FIRE SAFETY UPGRADE ASSESSMENT REPORT

To:	Gardner Design	Date:	19 March 2025
Attention:	Paul Pena Castra	Project Ref:	2565 REV A FINAL
From:	Nick Wilson		
Project:	2A Kangaroo Street, Manly		
Subject:	Preparation of fire safety schedule for Unit 2

Figure 9 –Location of lightweight walls in SOU 2 and 3.

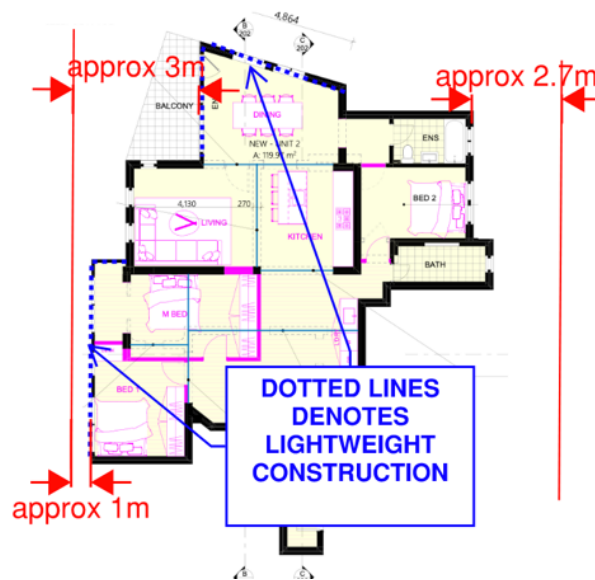
NO.	DTS CLAUSE	DESCRIPTION OF NON-COMPLIANCE	PROPOSED METHOD OF UPGRADE
2.	C2D10	<p>Non Combustible Building Elements</p> <p>As the building is required to be of Type A construction the external walls including the facade covering, framing and insulation must be non-combustible</p> <p>The subject apartment appeared to be generally of full masonry construction with the below external walls noted as timber framed which does not comply with this clause.</p> <p>BCA Clause S5C20 concession permits the use of timber framing in external walls for buildings with a rise in storeys of no more than three therefore the timber is permitted. The cladding and insulation is required to be non-combustible.</p>	<p>Timber framing permitted. The cladding and insulation is required to be non-combustible.</p> <p>Where external walls are modified the insulation is required to be non-combustible. See item 1 above.</p>

- 1) Lightweight external walls - Works are proposed to the lightweight external walls to the east elevation. The work must therefore include the installation of 2 layer of 16m fire rated plasterboard to the internal side of the subject lightweight wall to achieve an FRL of 90/90/90. Prior to the installation of the fire rated plasterboard, Rockwool or similar mineral wool batts are to be installed to the timber framed external wall cavity packed tightly between studs, noggings, top plate and bottom plate

Figure 13 –Location of unprotected openings within 3m of allotment boundary in SOU 2 and 3

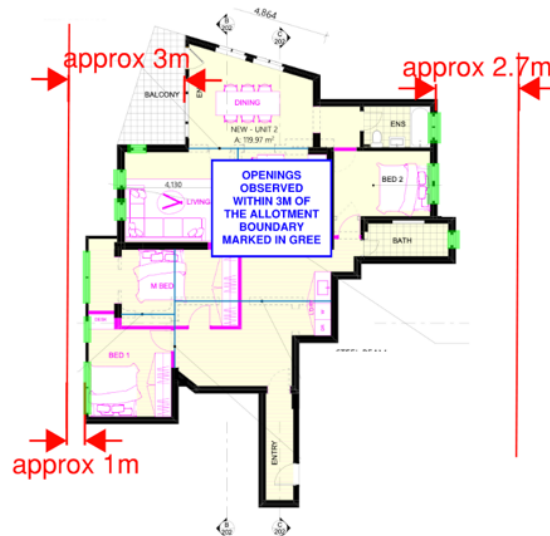
NO.	DTS CLAUSE	DESCRIPTION OF NON-COMPLIANCE	PROPOSED METHOD OF UPGRADE
6.	C4D3 C4D5	<p>Protection of openings in external walls</p> <p>Where openings are located within 3m of the side or rear boundaries, the openings are required to be protected in accordance with BCA Clause D4D5.</p> <p>Openings in the subject SOU were observed as being located at distances between approximately 2.7m through to 1m of the allotment boundary as per below and not protected in accordance with C4D5 therefore compliance with this clause is not achieved</p>	<p>No development works are proposed to the existing openings and no new openings proposed within the subject apartment.</p> <p>If it is determined that this non-compliance requires upgrade under the provisions of EP&A Clause 64 (b) (iii) a fire safety upgrade strategy is recommended to be obtained to permit or protect the openings.</p>

Figure 14 –SOU entry door to SOU 3 to common stair required to be a fire door

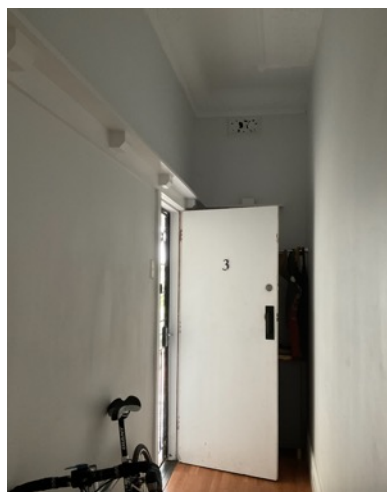
7.	C4D12	<p>Bounding Construction</p> <p>The entry door way to SOU 3 from the common corridor must be provided with a self-closing - /60/30 fire door.</p> <p>The existing door did not appear to be a fire door and was not provided with. self-closing device.</p>	<p>This door and door jamb is to be upgraded to a - /60/30 self-closing fire door under EP&A Clause 64 (b) (i) and (ii)</p>
----	-------	--	---

- 5) Bounding construction - The existing entry door and jamb from SOU 3 to the common corridor is to be upgraded to a -/60/30 self-closing fire door under EP&A Clause 64 (b) (i) and (ii)

Figure 16 –Proposed upgrade strategy measures

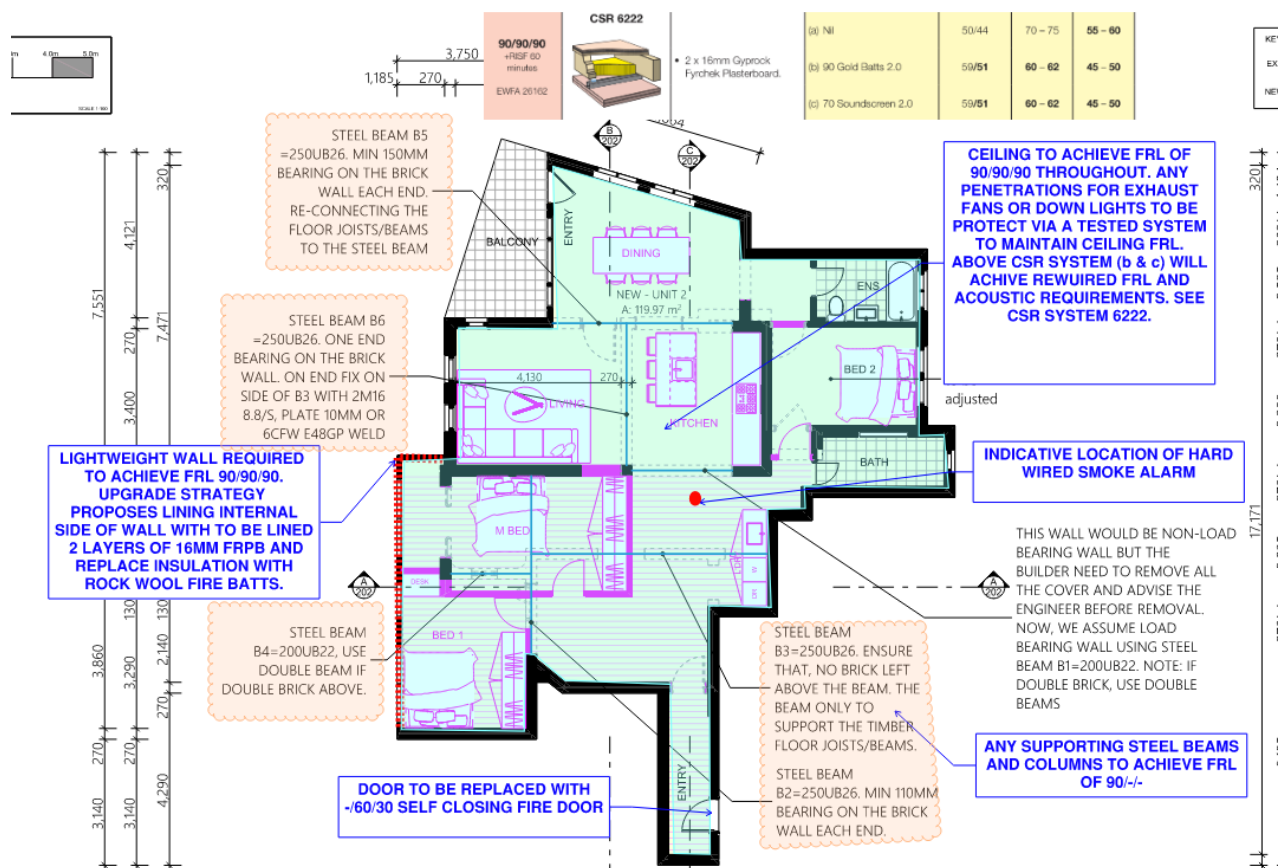
- 2) Floor/ceiling separation - The ceilings are also proposed to be modified and hence need to be upgrade with fire rated plasterboard to achieve an FRL of 90/90/90. Where possible it is also proposed to support the ceilings on furring channel and resilient mounts in accordance with CSR system 6222 to achieve the required sound insulation level.

- 3) Structural elements - Proposed steel beams and theirs supporting columns or walls required to supporting the floor / ceiling system above are to be protected to achieve minimum FRL of 90/-/-.

- 6) Smoke alarms - Hardwires interconnected smoke alarms are required to be installed in accordance with AS3740-2018 throughout the subject apartment (SOUS 2/3).
